Valley – Ivyglen Subtransmission Project CPUC Minor Project Refinement Form

MPR No. 8 is a proposal for additional work areas and land disturbances that were not included in NTPR-2 but are necessary to construct the Valley-Ivyglen 115 kV Project. Much of the proposed disturbance is outside of the general disturbance area of the VIG Project (Figure 1). The proposed work areas are of the sizes described in Table 2-5 of the FEIR as being necessary to construct the Project components.

Figure 1. Proposed Work Areas and Disturbances Associated with MPR No. 08.

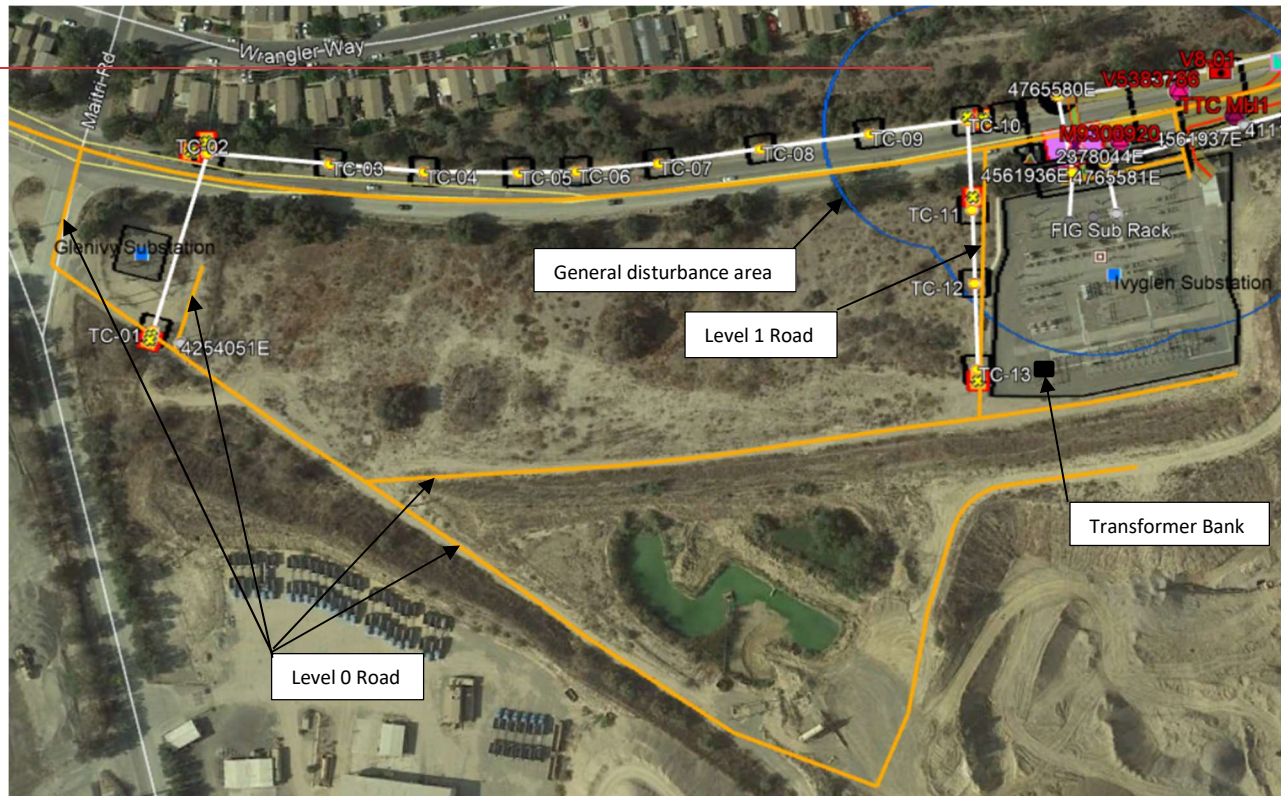
To accomplish this objective, SCE proposes in this MPR to route a branch line from a local 33 kV power circuit (known as the Terra Cotta circuit) from a nearby pole line into Ivyglen Substation, which would feed a temporary 33 kV/12 kV transformer bank installed inside the substation fence line. The 12 kV power from this transformer bank would connect to the existing 12 kV bus inside the substation, from which the 12 kV power would flow to the local distribution network served by Ivyglen Substation. SCE considers this approach to be the most reliable and safe means of maintaining 12 kV power to its customers on a temporary basis when 115 kV power is not available to Ivyglen Substation.

The proposed refinements would result in a net increase of 0.40 acres of temporary disturbance in Segment VIG8. The locations, area, and activities for each proposed refinement are provided in Table 1 and are visually shown in Figure 1.
